ADDENDUM No. 2

PROJECT: Lakeview Rd/Reames Rd Intersection Project
 Project No.: 512-16-032
 Bid Number: HC2020-1929

ROUNDABOUT TYPICAL SECTION

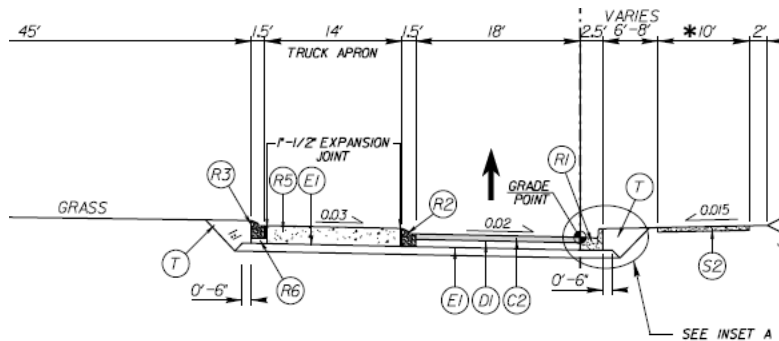
- Where will item 23, Class AA Concrete be used?

- Where will item 93, Traffic Signal Removal be used? TCP-1, General Notes C, states "All signal revisions or shifts of signal heads will be the responsibility of CDOT". SP-03R, Traffic Signals, states "CDOT will...relocate and remove all traffic signal equipment on the Project...". Please clarify.

- On the Itemized Bid, Line Item #105 – 12" Reinforced Stamped/Colored Concrete is for the Truck Apron R5 in the above detail. This line item description has been revised to include Class AA Concrete.

Answer: This item covers the Proposed 5" Concrete (Class AA) (R6). See revised line item description on the Itemized Bid.

Answer: The Itemized Bid item #93 is no longer needed and has been replaced with a new item for 1'-6" Concrete Curb and Gutter (Class AA Concrete). This item is for R2 in the above detail.
